# BALTIMORE COUNTY PUBLIC SCHOOLS

## ADDENDUM NUMBER \_\_4\_\_

DATE: December 12, 2016  
BID NAME: REPLACEMENT OF VICTORY VILLA ELEMENTARY SCHOOL  
BID NUMBER: ARA-209-17  
DUE DATE: **DECEMBER 21, 2016**  
DUE TIME: **2:00 P.M.**

C3.01  
1 OF 1

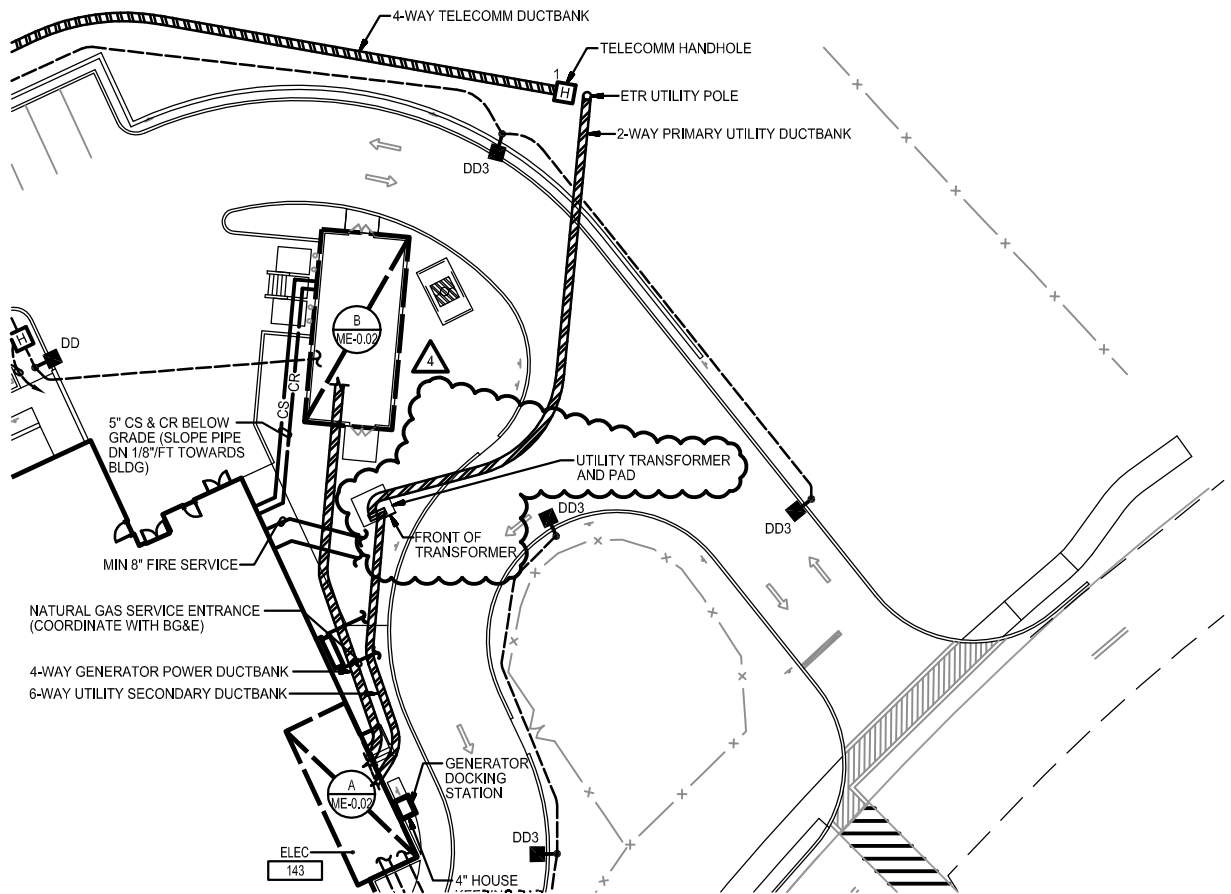
- a. **ADD:** New 6" pvc storm drain to profile 13.

**SITE PLAN - MECHANICAL AND ELECTRICAL**

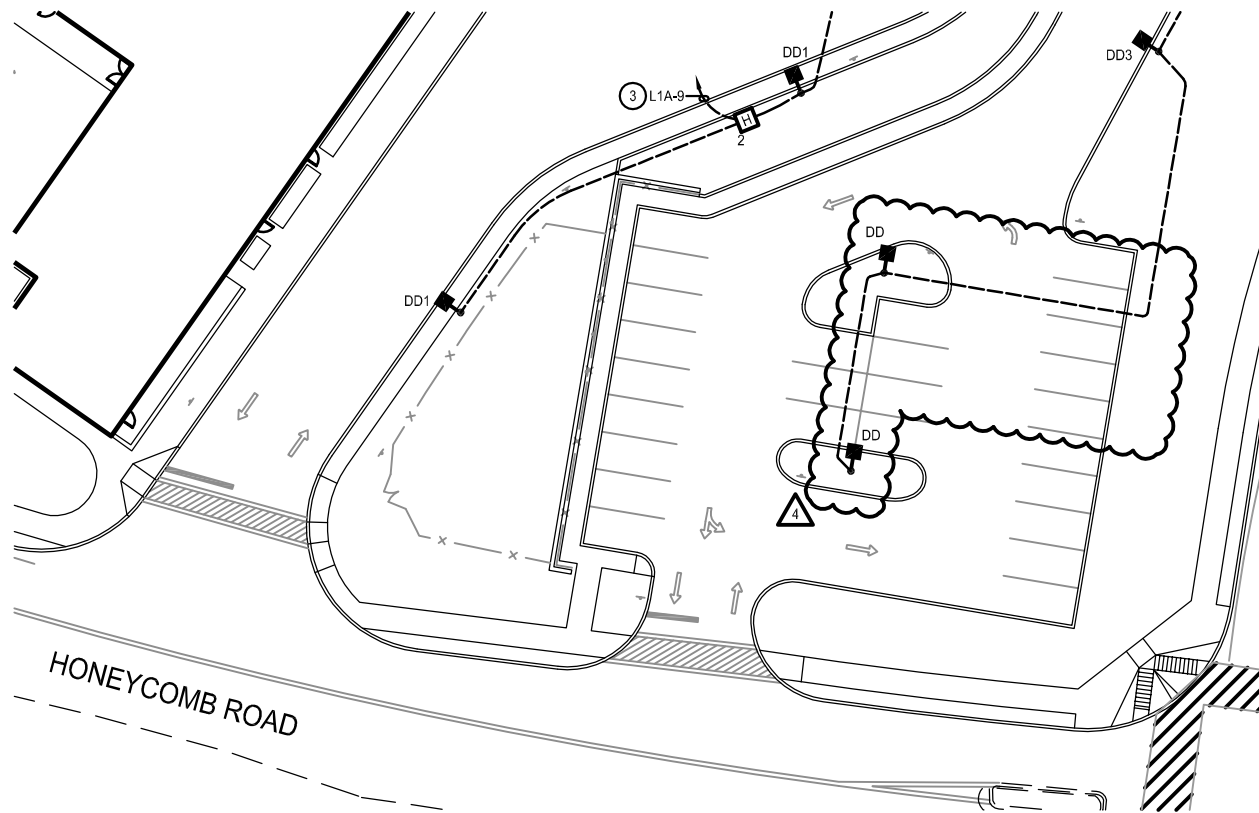
Revise per the attached sketches **ME0.01 (1 of 2) and ME0.01 (2 of 2)**.

S1.01/

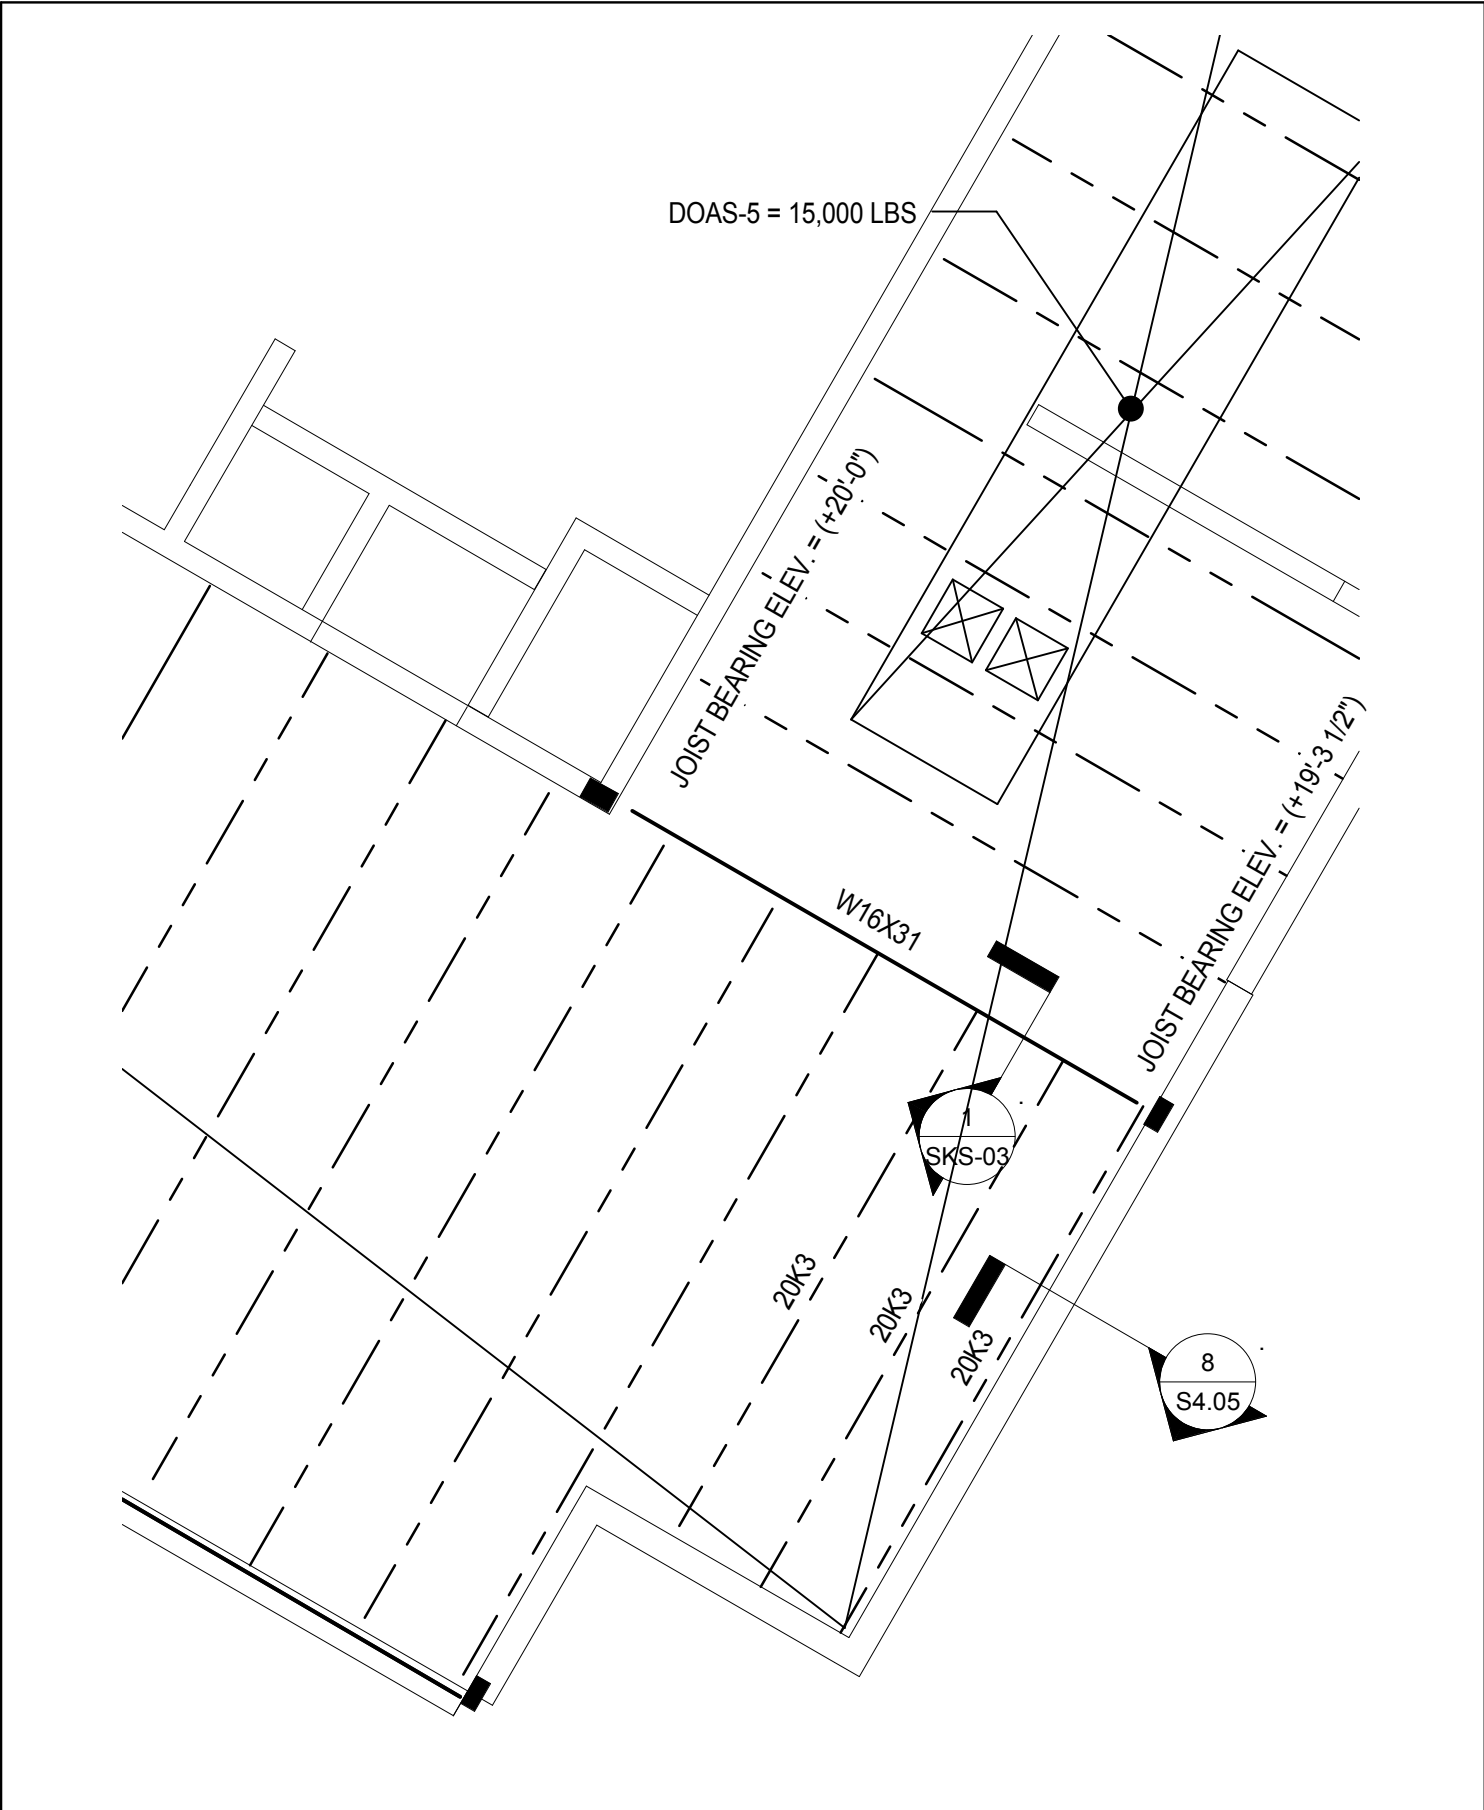
- a. **Revise per attached sketch**
- b. Revise FOUNDATION SYSTEM NOTE per Sketch S1.01/S1.02 1of 1 attached to this Addendum to read:  
Foundations shall consist of footings over rammed aggregate pier improved soils. **ALL WALL FOOTINGS** designed for 2.5 KSF allowable soil bearing and **ALL SPREAD FOOTINGS** designed for 5 KSF allowable soil bearing pressure. Refer to the Geotechnical Report Addendum 15228.D. by D.W. Kozera, Inc. dated November 1, 2016 for foundation system requirements and specification section 31 66 13.

- c. Revise Foundation Note 1 as follows (changes are in bold text):
  - 1. SLAB ON GRADE SHALL CONSIST OF 5" CONCRETE SLAB REINFORCED WITH 6x6-W2.9xw2.9 WWF POURED OVER 10 MIL POLY VAPOR BARRIER **OVER 4" OPEN GRADED STONE (No. 57)** OVER 12" GRANULAR FILL. INSTALL SLAB SUBGRADE PER THE FOLLOWING CONSTRUCTION SEQUENCE AND REFER TO GEOTECHNICAL REPORT FOR ADDITIONAL INFORMATION:

**S1.04**

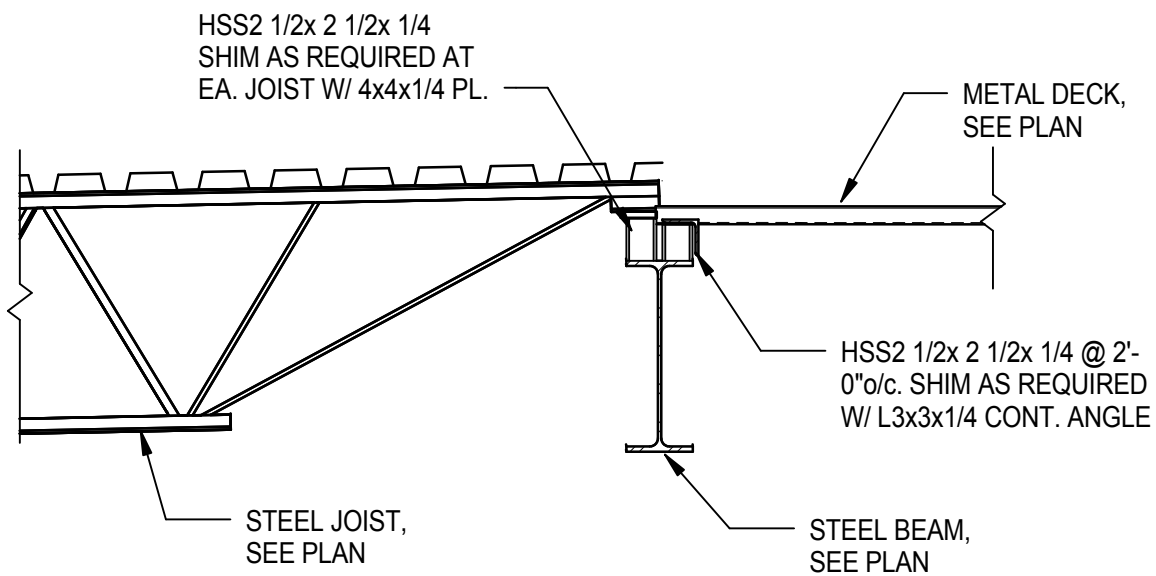
- a. Revise plan note #10 to read:  
FOR RTU SUPPORT FRAMING SEE TYPICAL DETAILS 6, 7, AND 8 ON S3.02.  
MAXIMUM WEIGHT OF RTU=500 POUNDS AND ARE LOCATED AS SHOWN.  
CONTACT ENGINEER IF FINAL UNIT LOCATIONS OR WEIGHTS DIFFER FROM THOSE SHOWN PRIOR TO JOIST FABRICATION.
- b. Revise per Sketch S1.04 1 of 1 attached to this Addendum
